Well Name: LOGAN 35 FEDERAL	Well Location: T17S / R27E / SEC 35 / NWSE /	County or Parish/State: EDDY / NM
Well Number: 4	Type of Well: OIL WELL	Allottee or Tribe Name:
Lease Number: NMNM117806	Unit or CA Name:	Unit or CA Number:
US Well Number: 300153043700S1	Well Status: Producing Oil Well	Operator: REDWOOD OPERATING LLC

Notice of Intent

Type of Action Plug and Abandonment

Plug Abandonment NOI Proposed

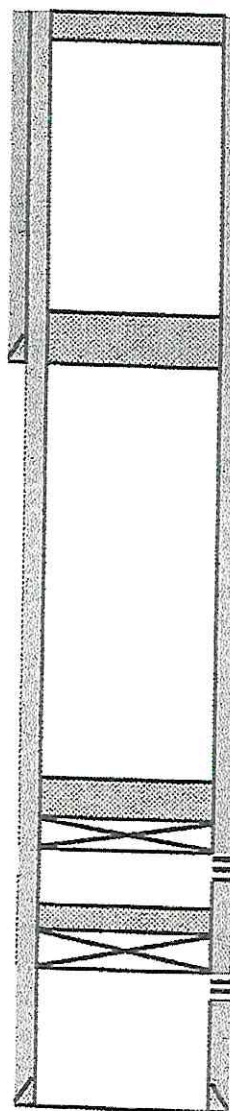
1. Tag 5 1/2" CIBP @ 3020'. ~~Dump bailed 35'~~ or spot 25 sx cmt @ 3020-2820'. WOC & Tag
2. Set 5 1/2" CIBP @ 1955'. Circ hole w/ MLF. Pressure test csg. Spot 25 sx cmt @ 1955-1755'. WOC & Tag.
3. Spot 40 Sx cmt @ 1202-860'. WOC & Tag (8 5/8" Shoe & Queen)
4. Spot 25 sx cmt @ 200' to surface.
